**RE: 27 Tiral Street SSD-35370706 Mod2 Design Statement**

In my professional opinion, the proposed changes to the design represent an improvement to the project's functional and amenity outcomes and remain consistent with the design intent established in the SSDA approval. The table below describes the Proposed changes to the RACF and Building B;

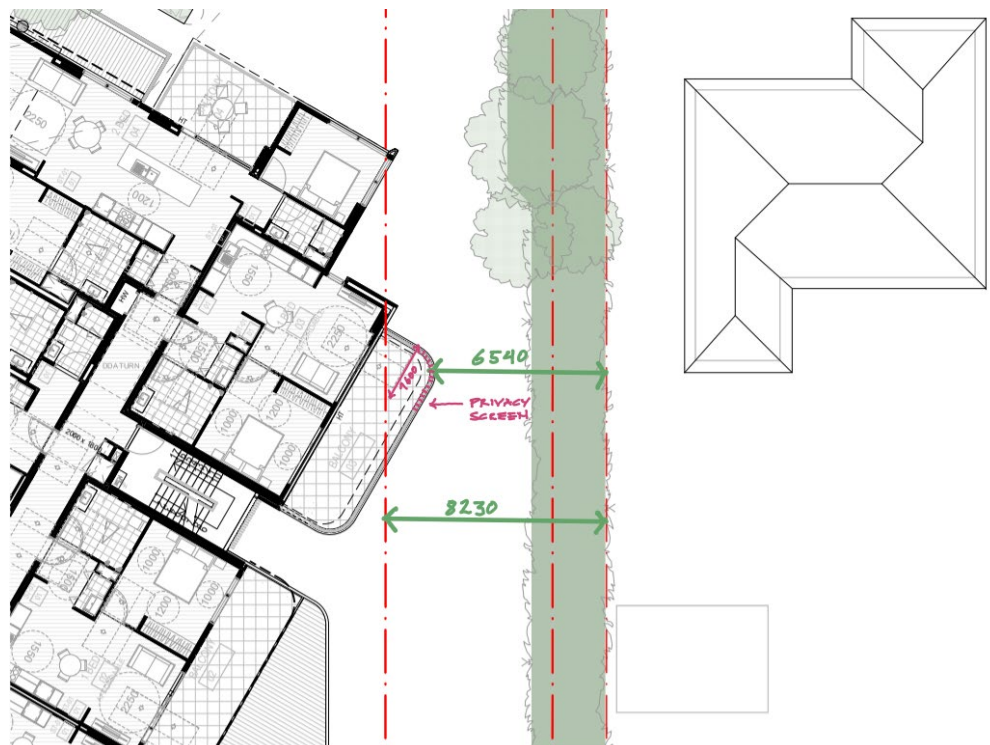
- The proposed Level 1 north-eastern balcony to the ILU in Building A has been assessed for potential visual amenity impacts on the adjoining property at 28 Tiral Street. While the balcony projects beyond the nominal 6-metre setback, the site is separated from the neighbouring property by an intervening strip of Council-owned land. This effectively maintains a visual separation consistent with the 6-metre setback recommended by the ADG. To further mitigate any potential overlooking, a privacy screen is proposed to the balcony, as illustrated in the sketch below. Accordingly, the combination of adequate separation and the introduction of a privacy screen ensures that visual privacy and residential amenity are maintained for occupants of both properties.

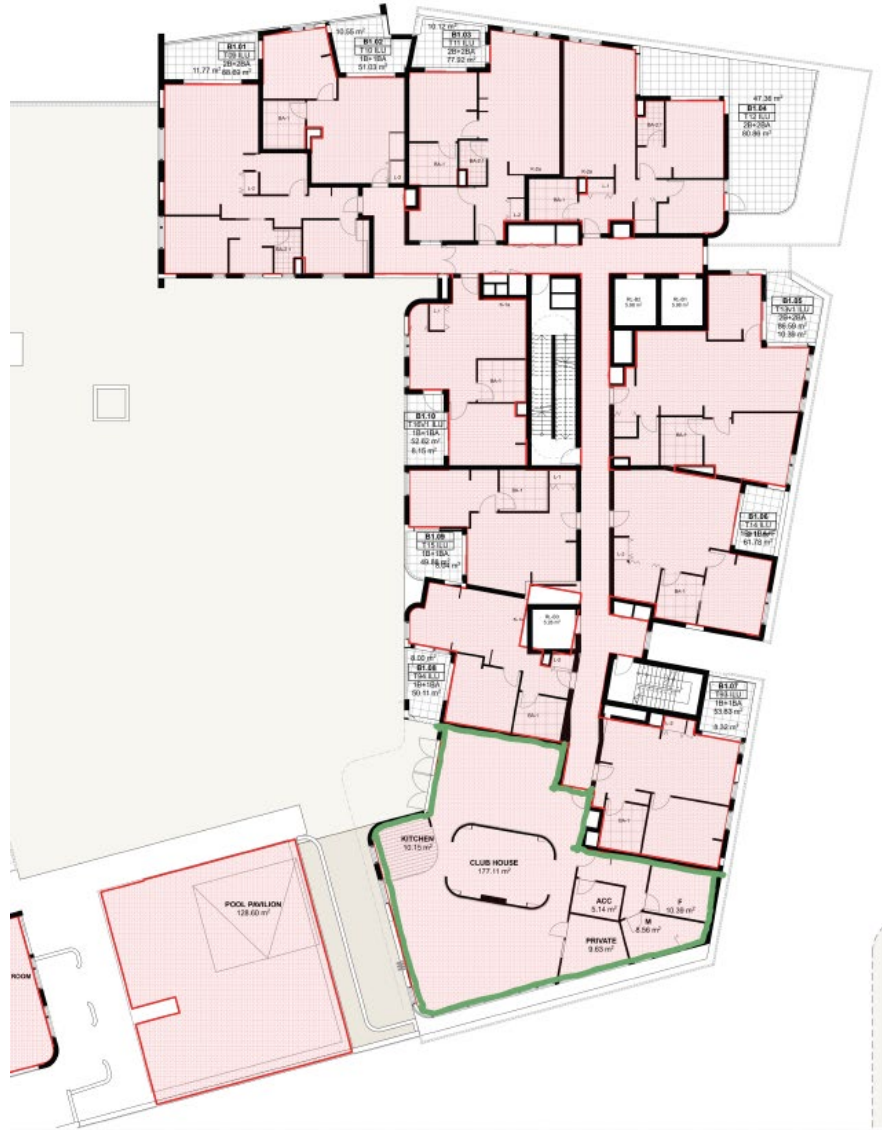
- The proposed additional window to the south-eastern wall of the communal space in the Residential Aged Care facility significantly enhances internal amenity for residents. Given that residents typically spend most of their time within their household, the quality of internal spaces is critical to wellbeing. The window is located behind the 6-metre setback, and when combined with the separation provided by the intervening Council-owned land, a total separation of over 8 metres is maintained. This ensures that the proposal preserves privacy and does not adversely impact neighbouring properties.
